Bulletin No. SA-006
Date: 1 March 1989
Page 1 of 1

SUBJECT: Replacement of Seat Back Adjustment Bracket

MODELS AFFECTED: All SGS 1-26D and SGS 1-26E

SEAT ADJUSTMENT BRACKET

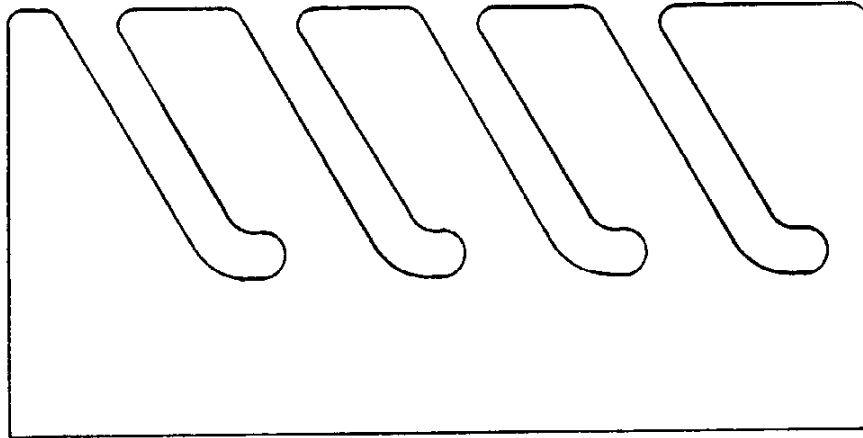
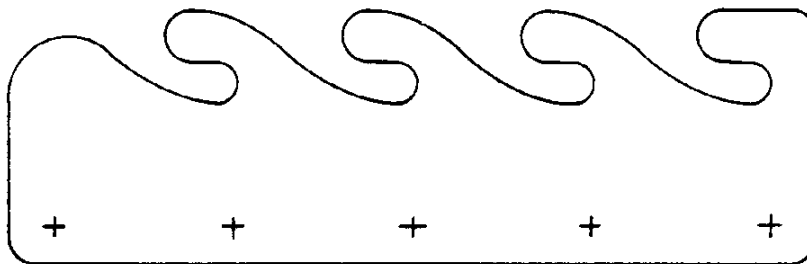
PREFACE: Reports indicate that on the affected aircraft, the pilot's seat back could inadvertently slide back during tow, when experiencing turbulence or during certain flight attitudes where a negative g condition may exist.

A new bracket, (PN26245D-3), and spacer, (PN26245D-5), has been designed to resolve this problem. This service bulletin lists instructions to install this improved seat back adjustment bracket. This improved bracket should reduce the possibility of sudden seat back movement.

- Drill out rivets securing existing seat adjustment brackets. Remove brackets.
- Clean up bracket mount area removing any burrs and sharp edges.
- Paint bracket mount areas with a thin coat of Zinc Chromate or equivalent primer to prevent corrosion.
- Place the spacer between the inside fuselage wall and the lower edge of bracket.
- Mark the mount area and drill holes as per old bracket using a #30 drill bit and secure with Cleco.
- Install rivets (MS20426AD4) (5) places on each bracket and spacer kit.
- Paint exterior of rivet heads.
- Record compliance with this service bulletin in the aircraft log book.
